LETTER OF TRAN	NSMITTAL					
TO:	TOWN O	F CANANDA	IGUA DEV. OFFICE	DATE: 19-Aug-2	21				
	5440 ROUTE 5 & 20 WEST ROCHESTER, NY 14620			JOB: BOYER SITE PLAN					
				RE: PRC COMMENT RESPONSE					
ATTN:	SHAWNA BONSHAK								
WE ARE SENDING: X ATTACHED			_UNDER SEPARATE COVER						
	SHOP DRAWINGS			SPECIFICATIONS	OTHER CHANGE O	RDER			
	COPIES DATE			DESCRIPTION					
	1	8/18/2021	UPDATED SITE PL	ANS (MEAGHER EN	GINEERING)				
	1	8/17/2021	UPDATED LOT LINE ADJU	ISTMENT MAP (WILLSON & ASSOCIATES)					
	1	8/19/2021	COMMEN	T RESPONSE LETT

## RE: CPN-21-067 Meagher Engineering, 2024 W. Henrietta Road, Suite 2C, Rochester, N.Y. 14623; representing Nicole R. and Conor J. Boyer, owners of property at 3548 County Road 16.

Boyer Site Plan – Town of Canandaigua PRC Comment Response Package

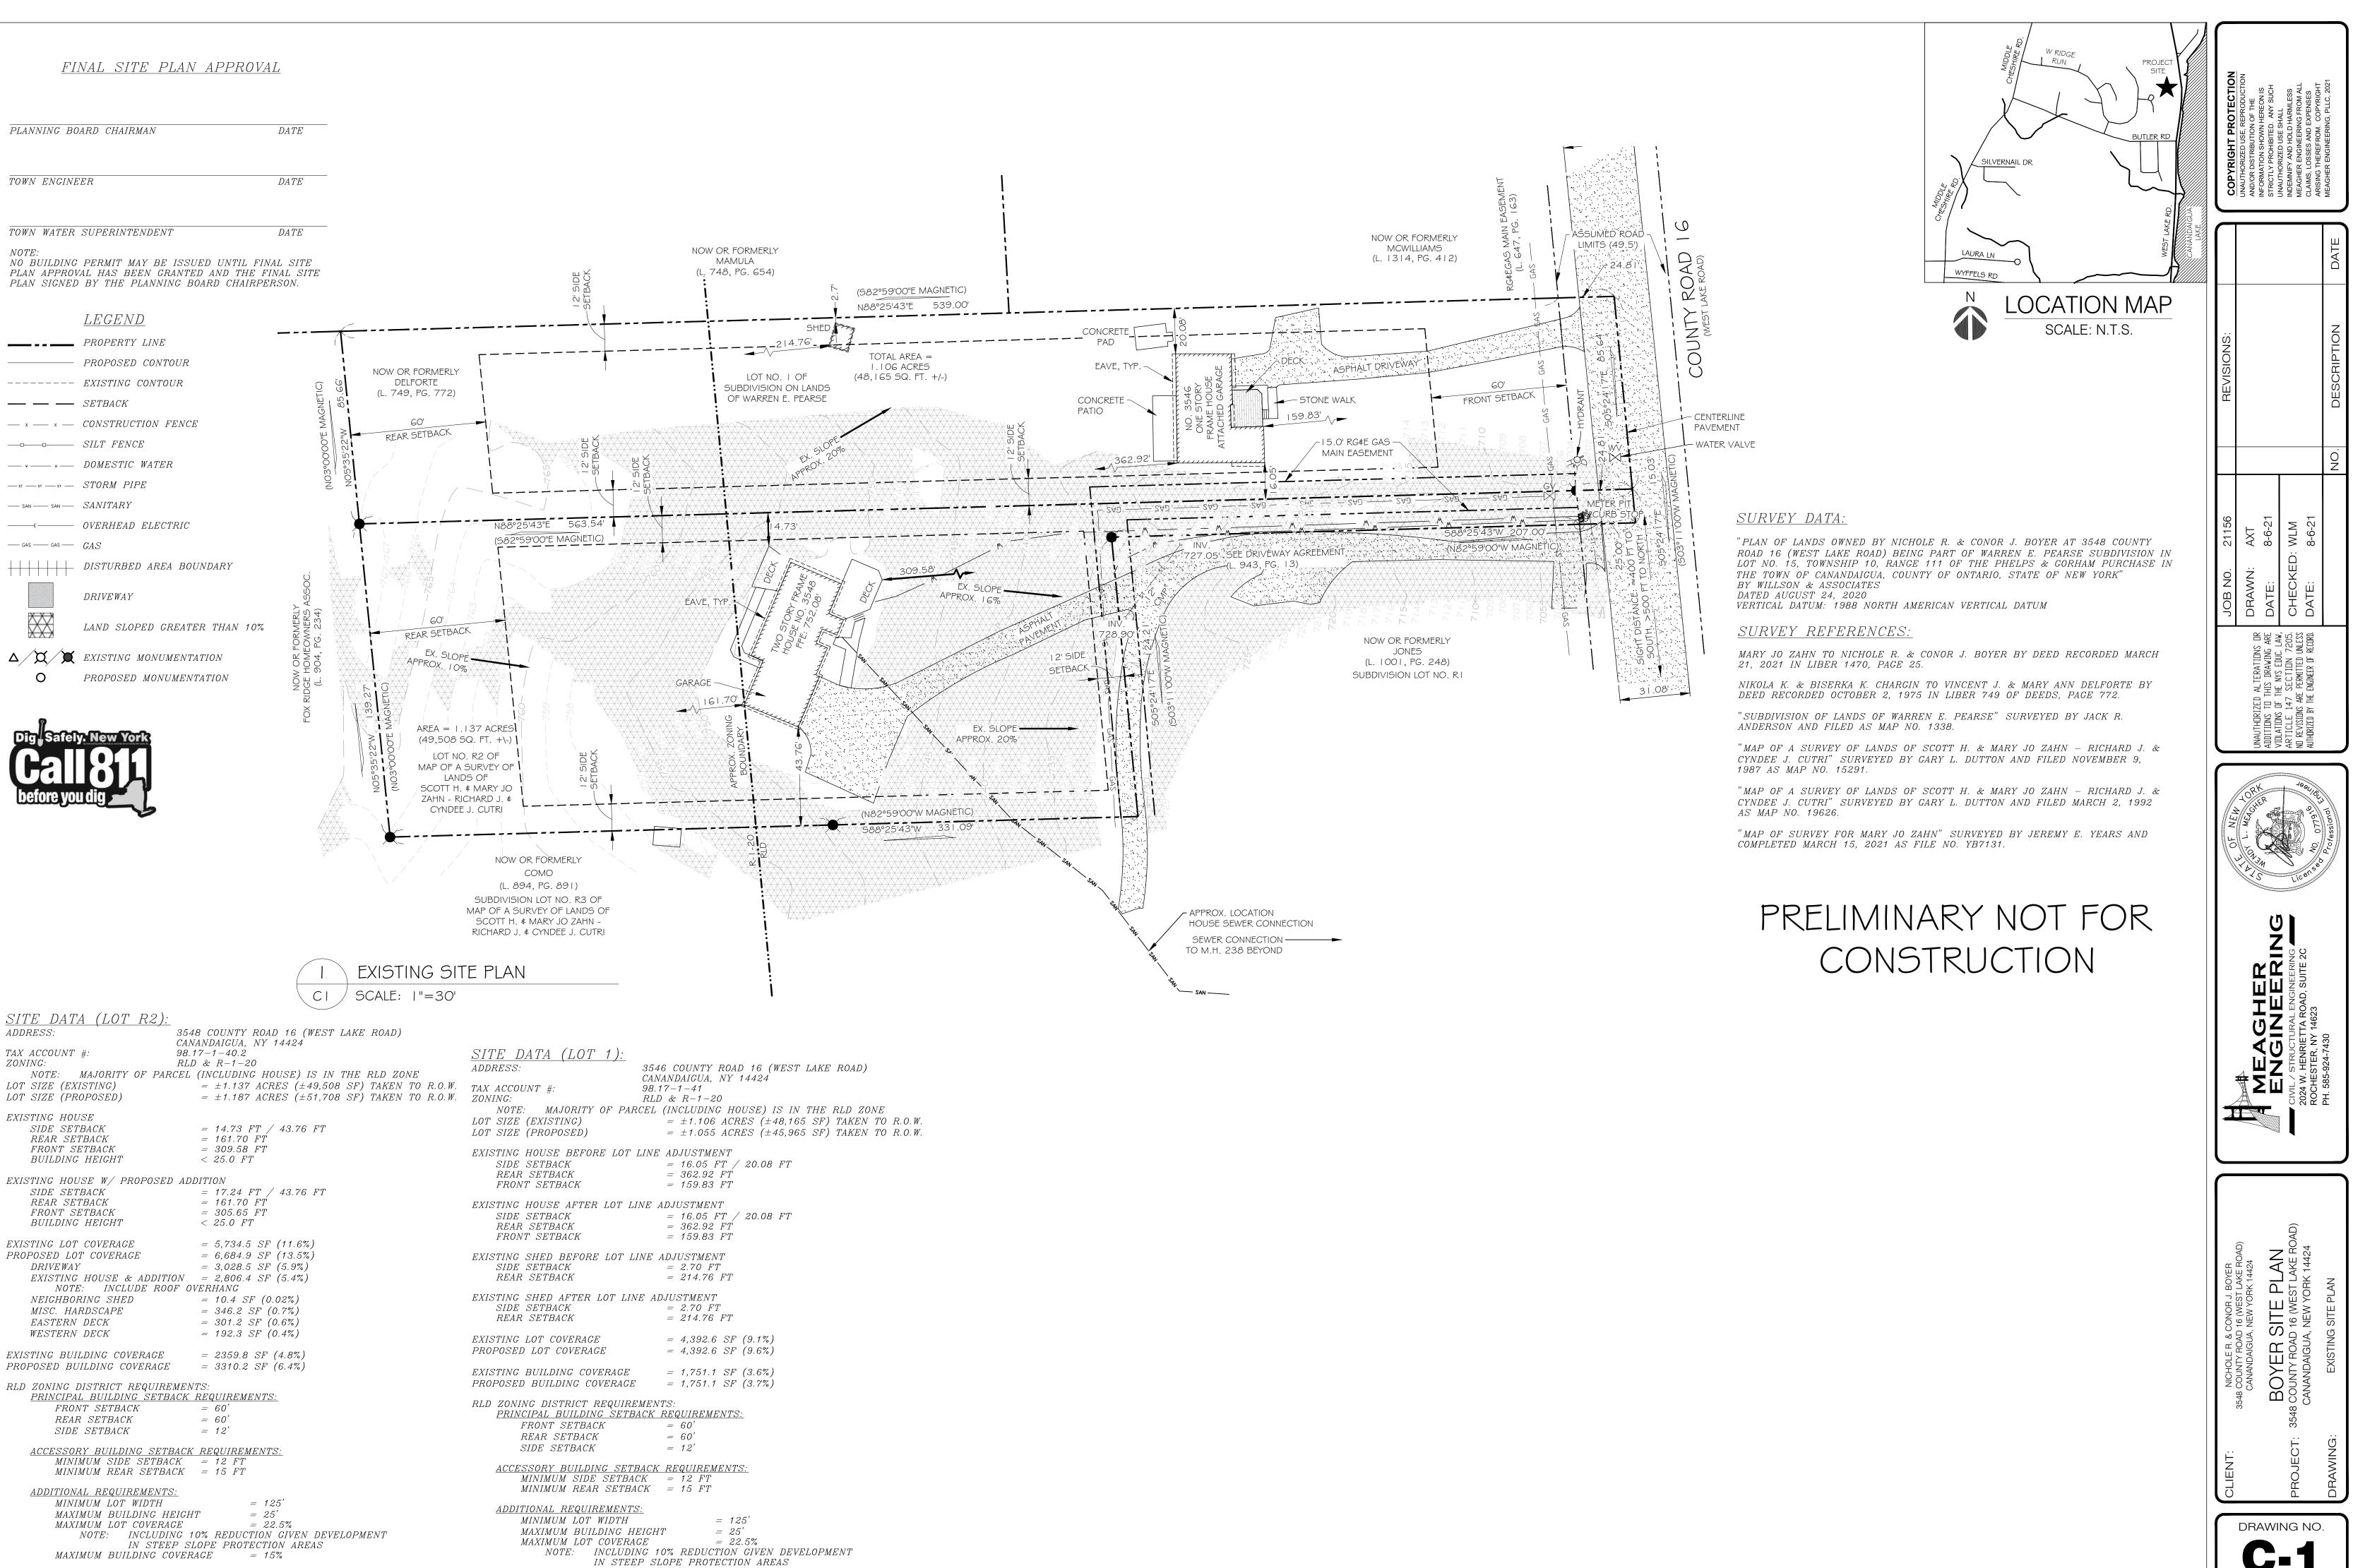
3. Submit a separate drawing of the proposed lot line adjustment and subdivision.

Understood. Drawing provided matches that in email from Rick Willson provided 8-18-21.

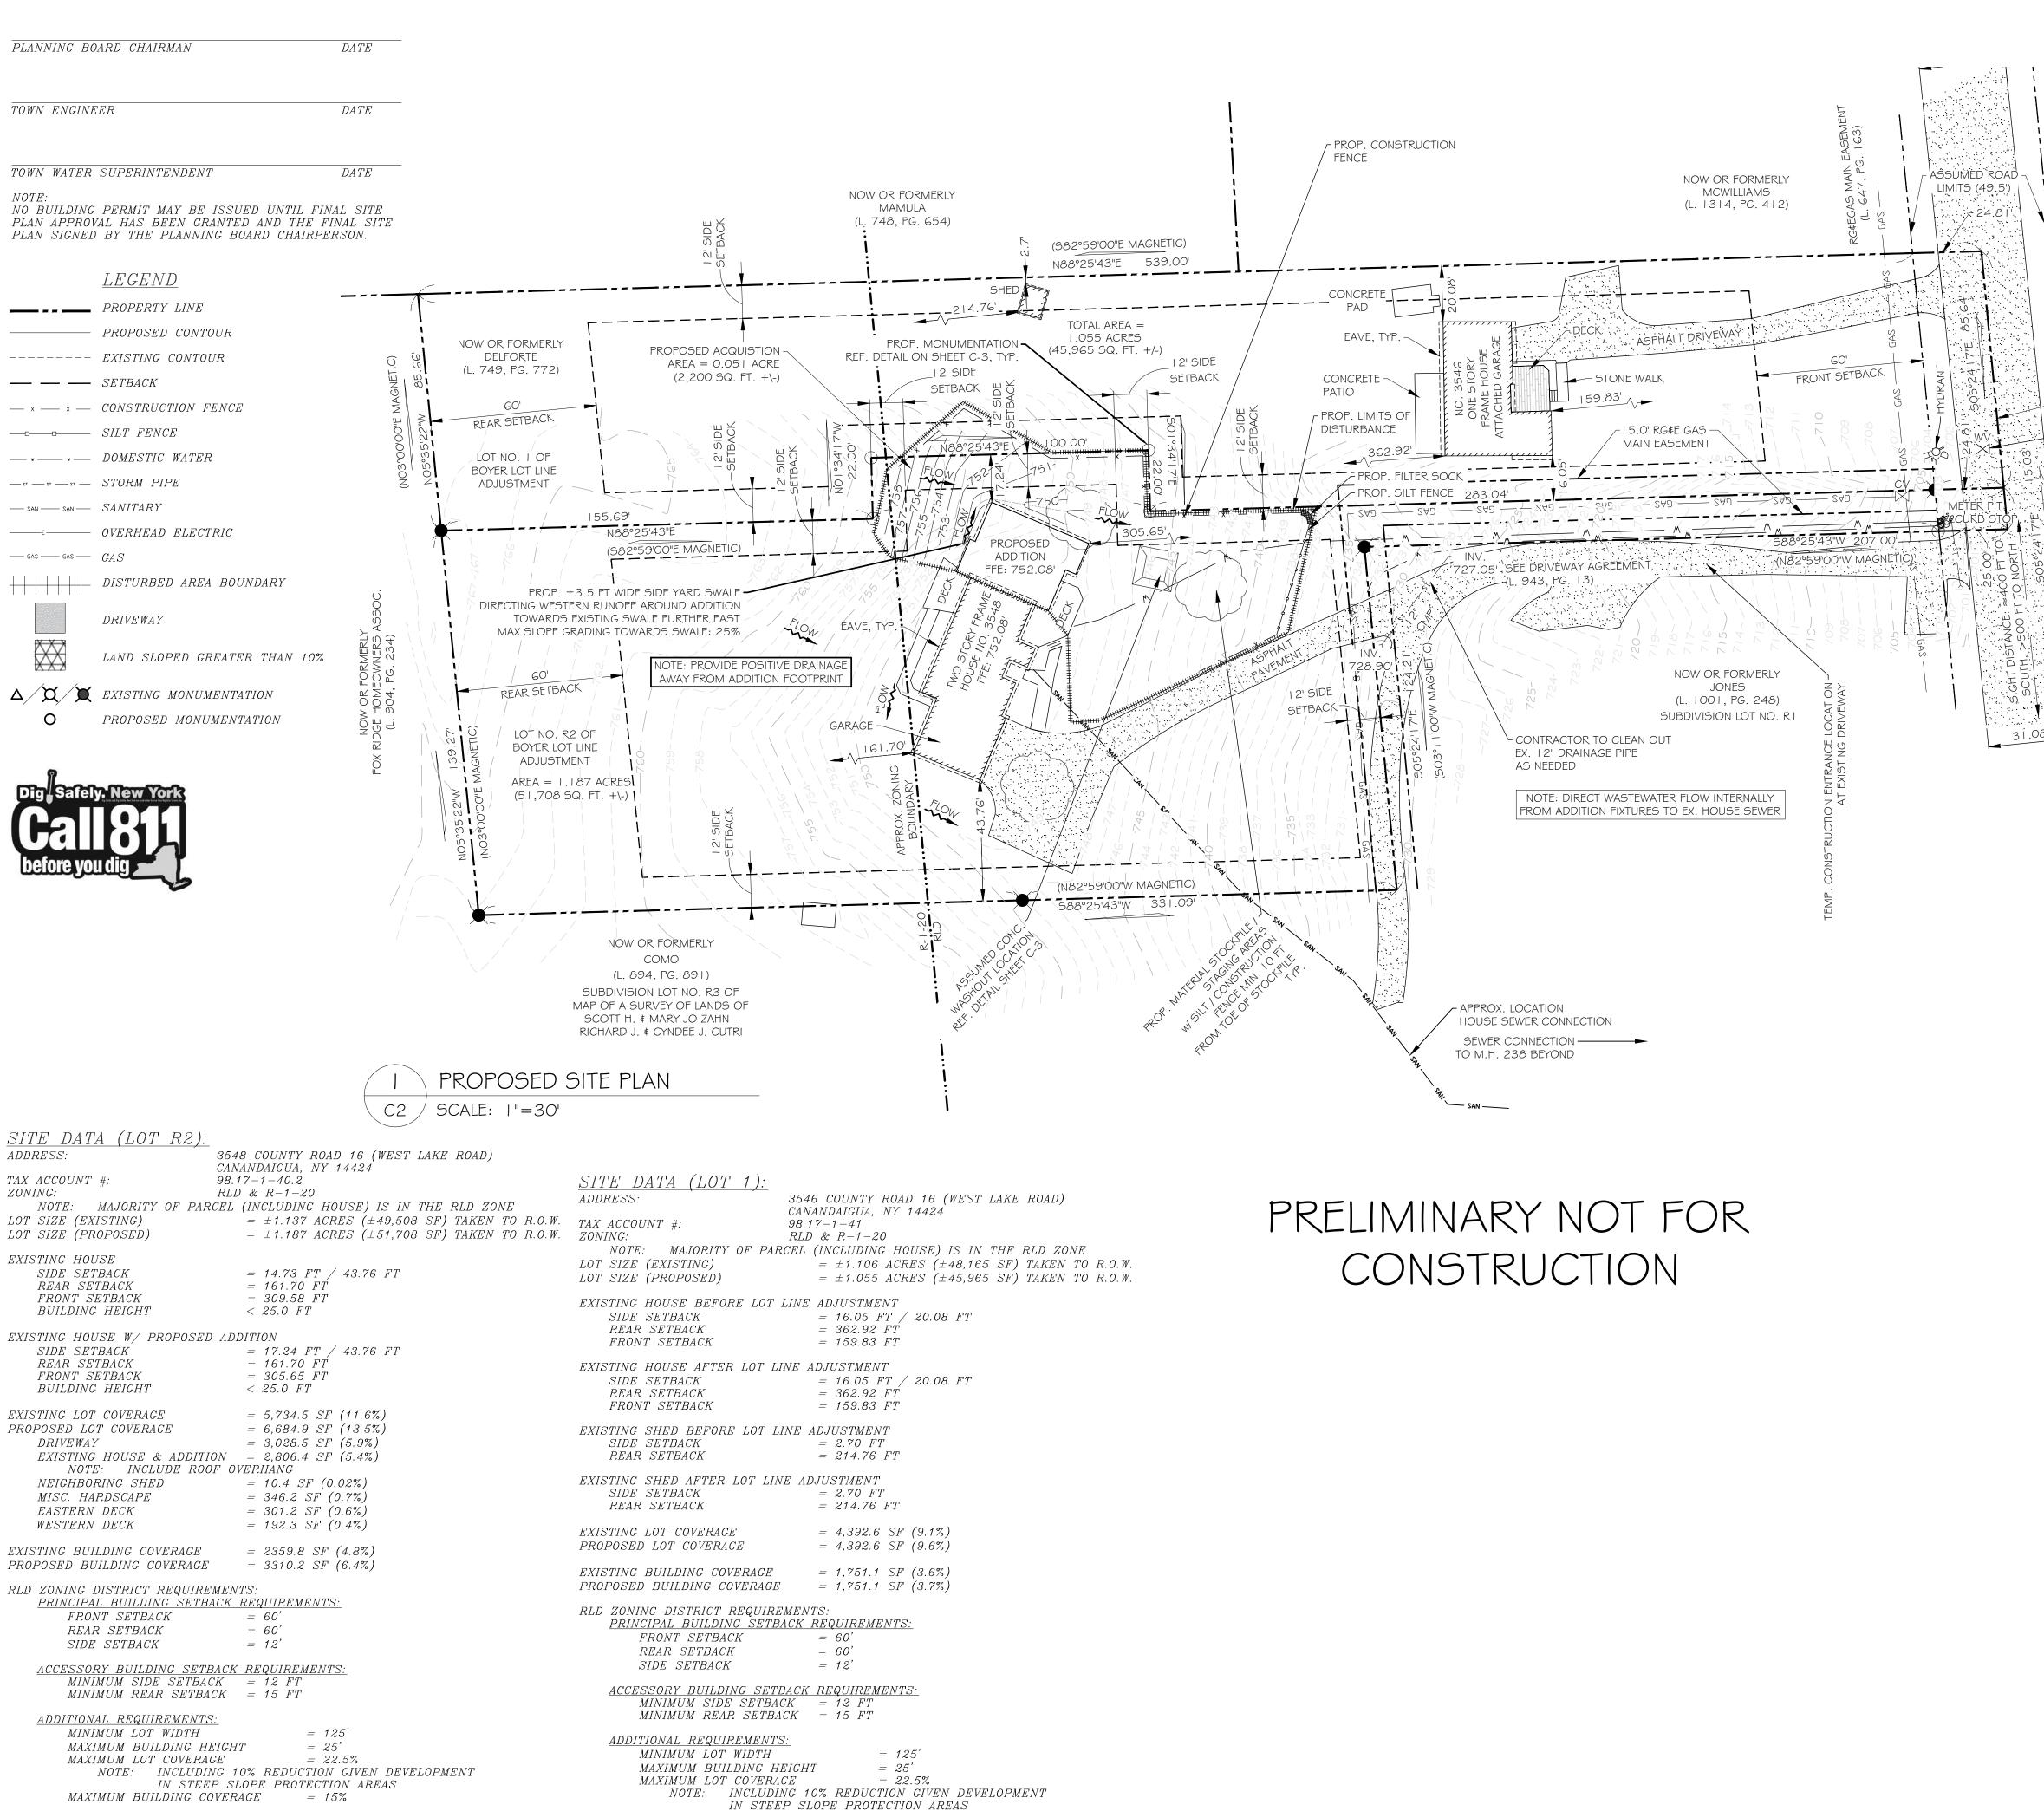
- Preliminary Site Plan Checklist (C) (2) (i) [8]: How will it flow around the addition?
  - Please refer to the updated Sheet C-2 (PROPOSED SITE PLAN) for flow arrows indicating how stormwater will flow around the addition as well as additional notes.

5. Show how stormwater will flow around the addition.

Please refer to the updated Sheet C-2 (PROPOSED SITE PLAN) for flow arrows indicating how stormwater will flow around the addition.
